**AGENDA
PLANNING & ZONING BOARD
SEPTEMBER 20, 2018
6:00PM**

WESTMINSTER PINE RIDGE ROADWAY & UTILITY DEVELOPMENT CONSTRUCTION PLANS CITY OF FRUITLAND PARK, FLORIDA

APPENDIX B

ENTRANCE ROAD - SITE GEOMETRY,
SIGNING AND MARKING PLAN

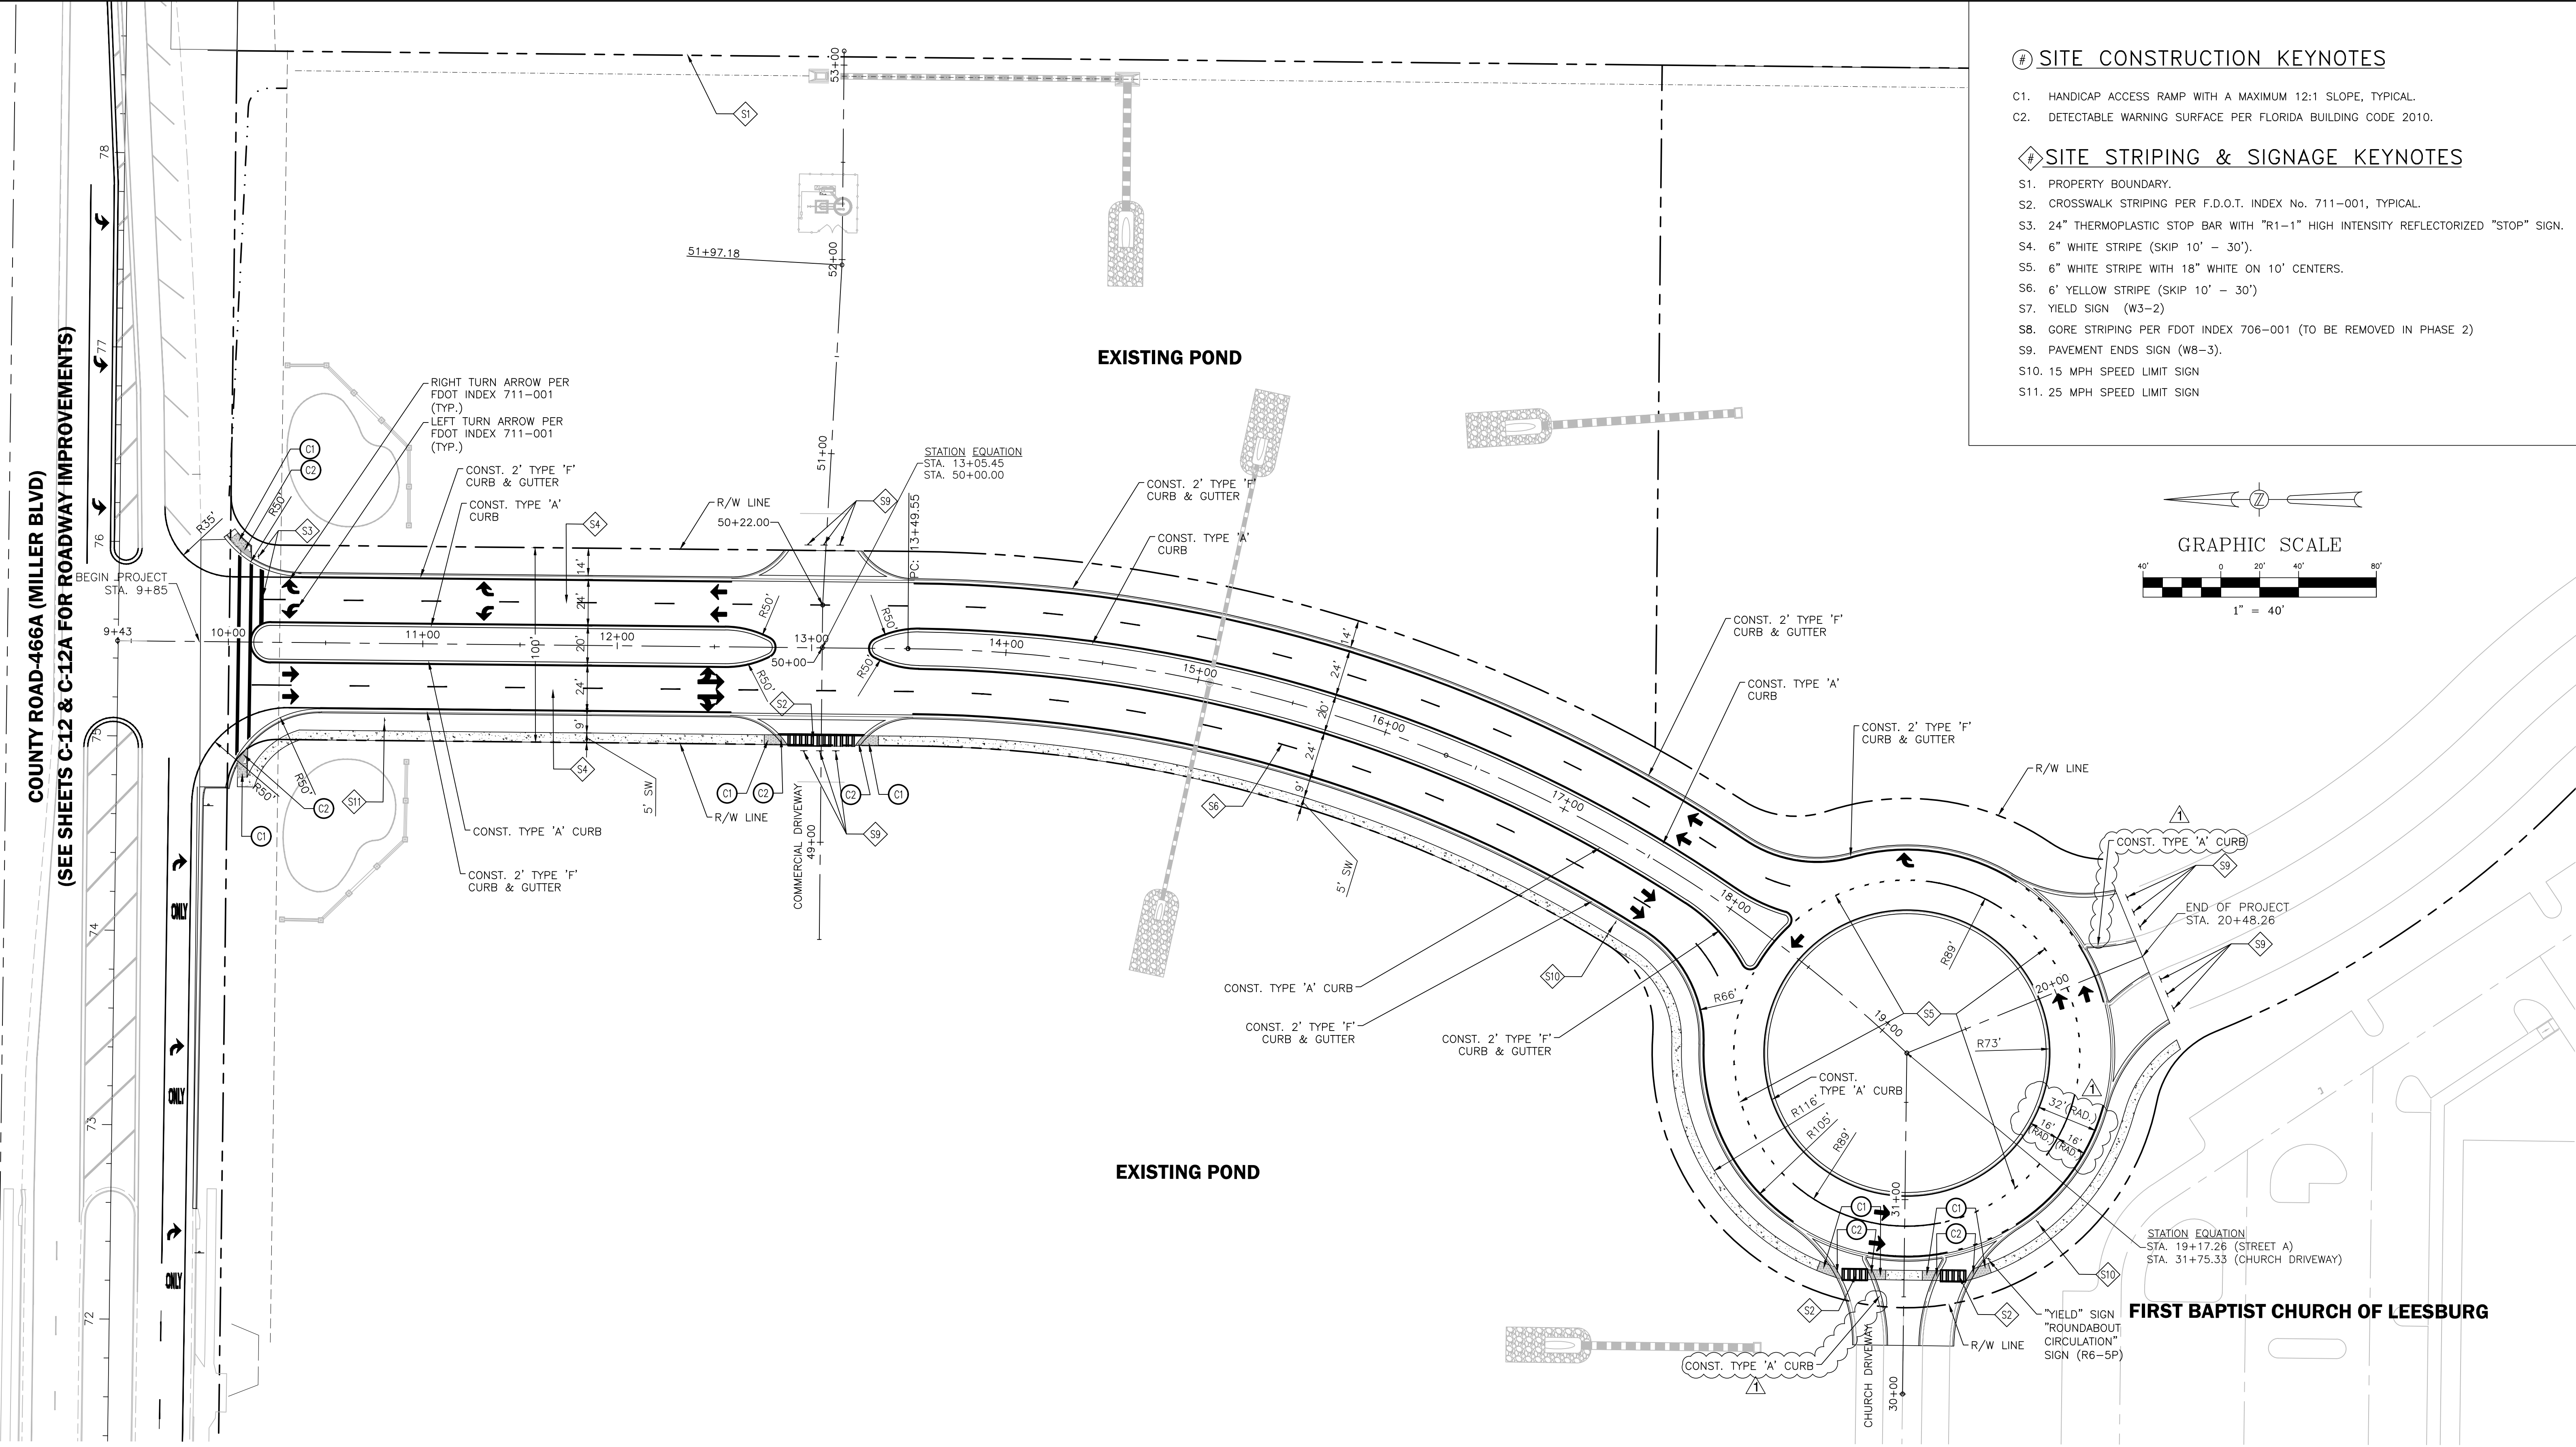
6. Sheet C-9 – At the roundabout, label the lane width and the total pavement width.

7. Sheet C-9 – At the roundabout, label the curb type at the drive aisle intersections.

Response: Sheet C-9 has been revised to add lanes widths and total pavement width at the roundabout as directed.

Response: Sheet C-9 has been revised to label curb types at the intersections as directed.

ENTRANCE ROAD - PLAN AND PROFILE

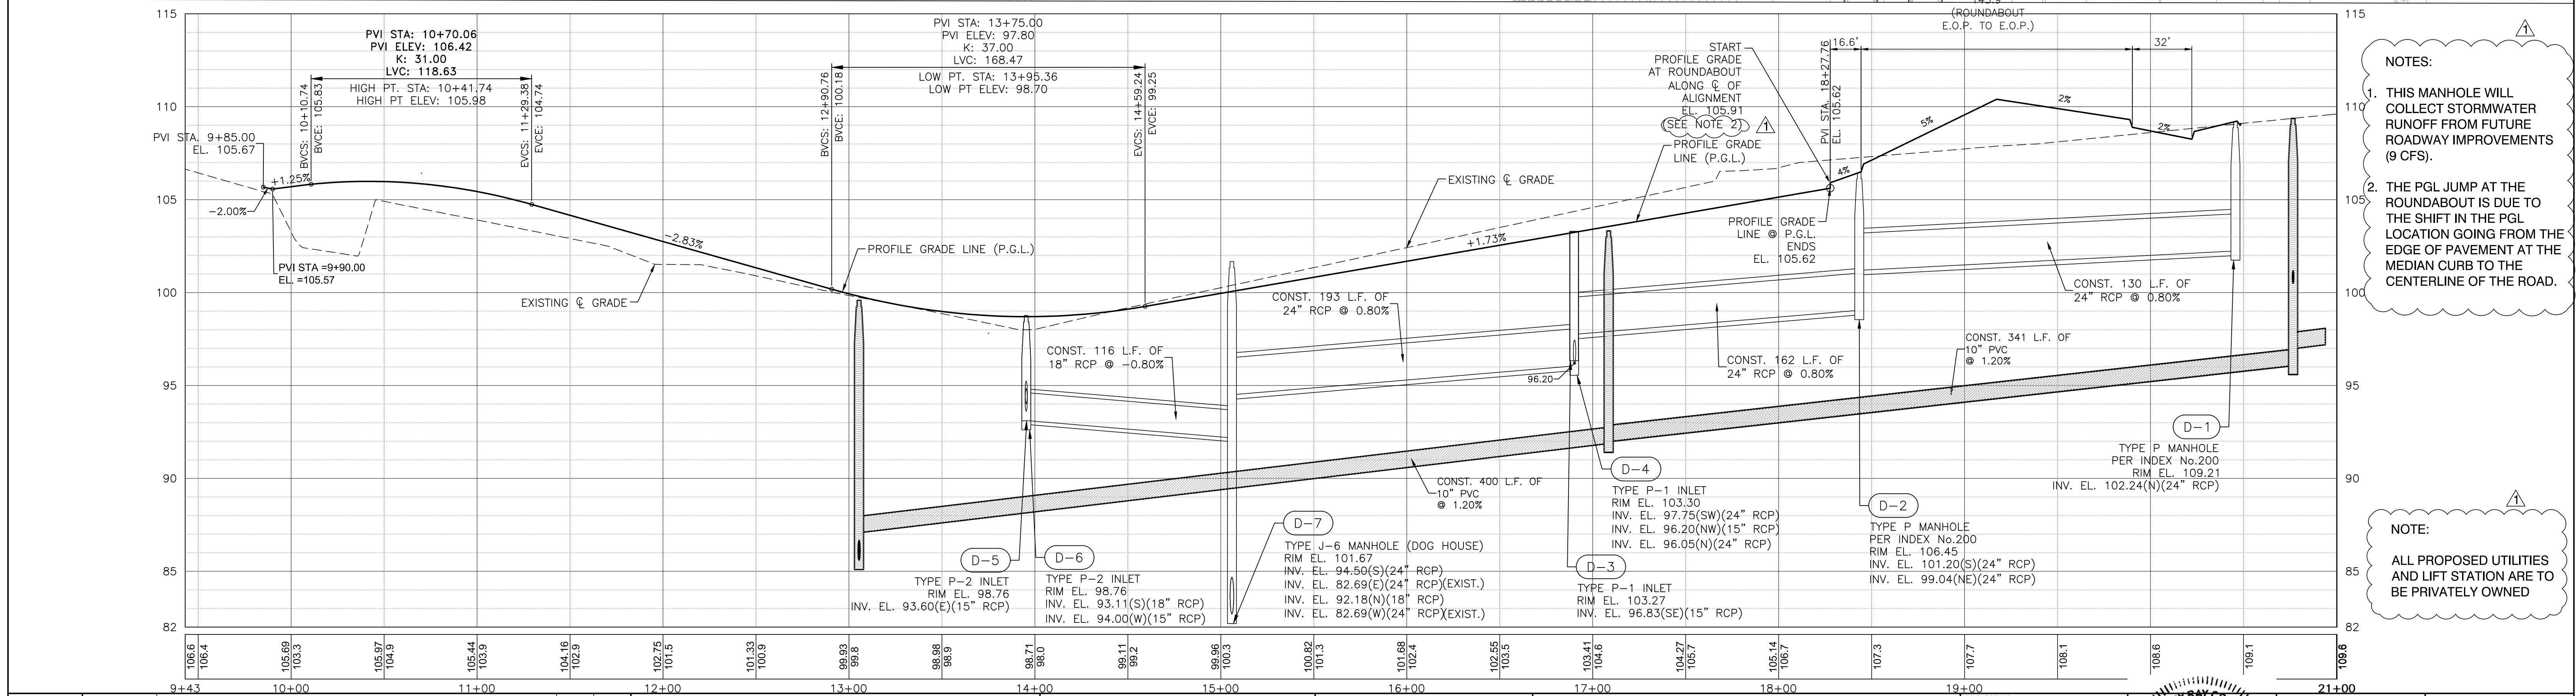
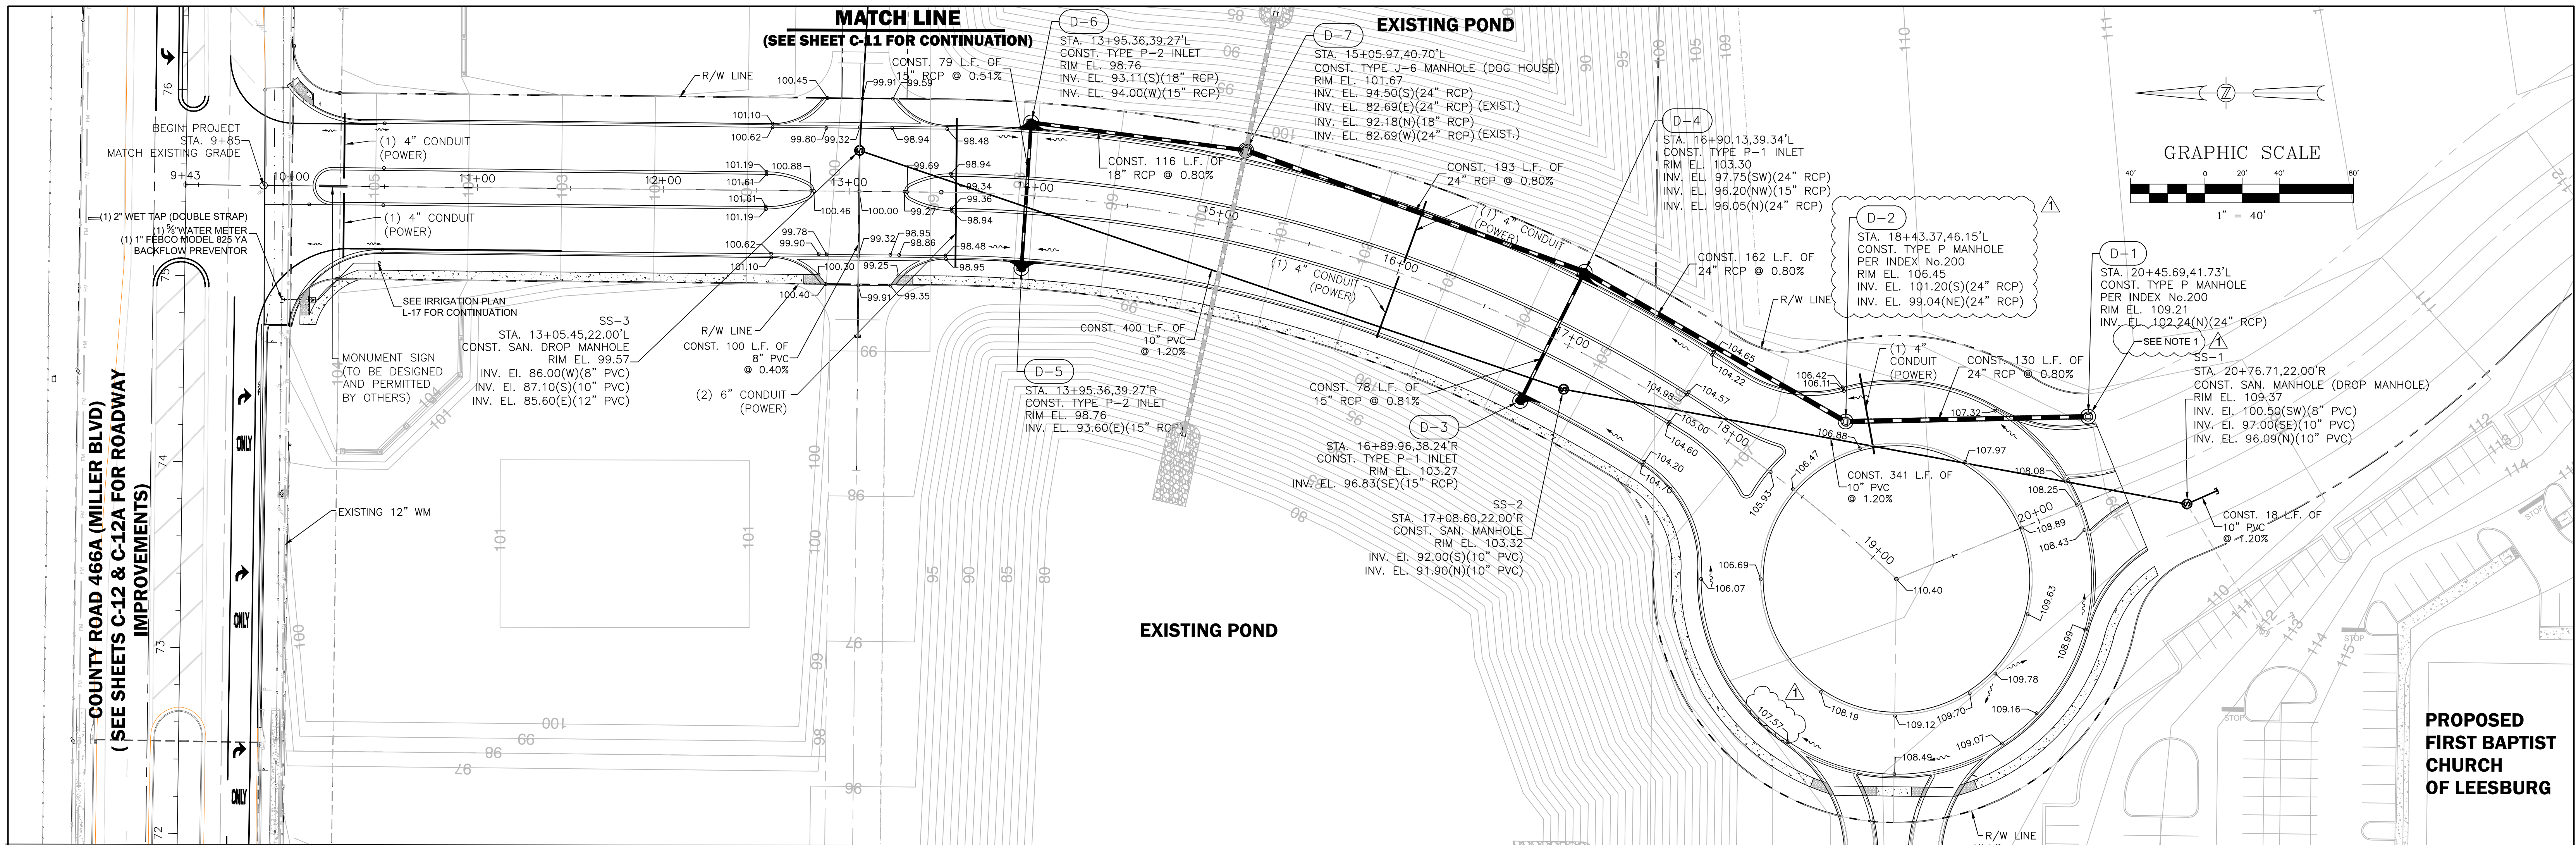
8. Sheet C-10 – Label structure D-2 in the plan view.

9. Sheet C-10 – Add additional spot grades around the roundabout and at the driveway stub outs to clarify grading.

10. Sheet C-10 – Please clarify the grading as the proposed roadway enters the roundabout. There are two separate profile grade lines that overlap, and do not meet at the same grade.

Response: Sheet C-10 has been revised to show label structure D-2 as directed.

Response: Additional spot grades has been added to sheet C-10 has as directed.

Response: The profile grade line has been revised on sheet C-10 to show a single profile line as directed. Also, please see added note 2 on revised sheet C-10.
